October 16, 2017

Commissioner Tom Landwehr  
MN Department of Natural Resources  
ATTN: PolyMet NorthMet Project  
500 Lafayette Road N, Box 45  
St. Paul, MN 55155-4045

Thank you for the opportunity to submit comments for the NorthMet Draft Dam Safety Permits Nos. 2016-1380 and 2016-1383. These permits are a mere eight pages, but the length of the permits belies a basic truth about the proposed NorthMet Mining Project: by design, these dams are expected to hold back mine waste forever. To reiterate: earthen berms rising 250 feet above the surrounding area and constructed on top of 50 year old mine waste slurry are expected to contain 225 million short tons of powdered rock and water, and to do so indefinitely without unreasonably risking the public's health, safety, or welfare.

Figure 20: Sulfate concentration graph at well MW-05-02.

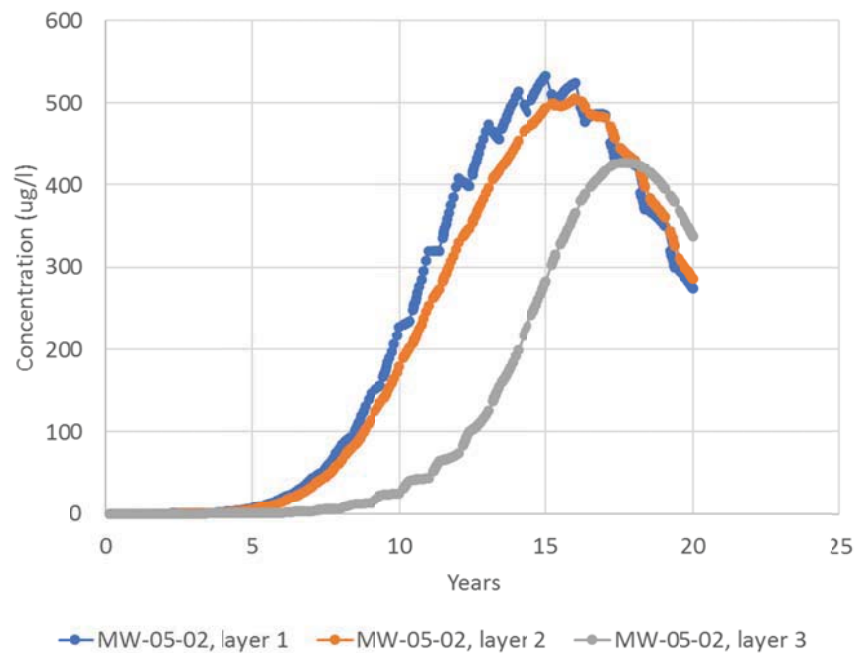
02 lies toward the south portion of the site, and its concentration peaks at about 15 years (Figure 20),but varies by layer.

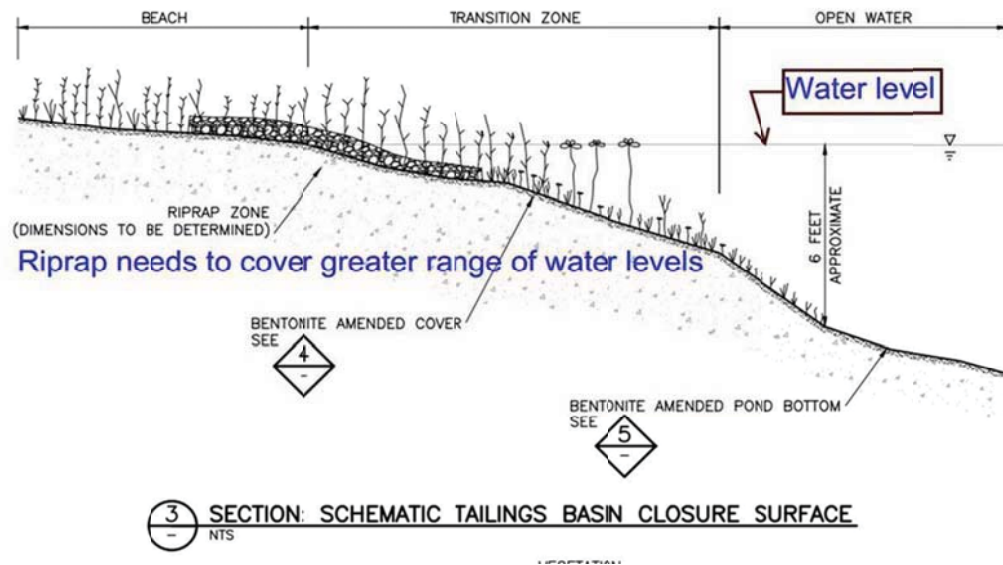
1. As shown on the drawings, (FTB-009) none of us completely understand the function of the 4-foot thick coarse LTV tailings underdrain beneath lifts 1 and 5 along the north face of the embankment. It appears that the underdrain will collect and direct surface run-off into the embankment, potentially saturating the embankment, and reducing the stability. This item requires further explanation and review. (see first image below) We don't think that the purpose of the underdrain is to collect surface water, but that's what is illustrated.
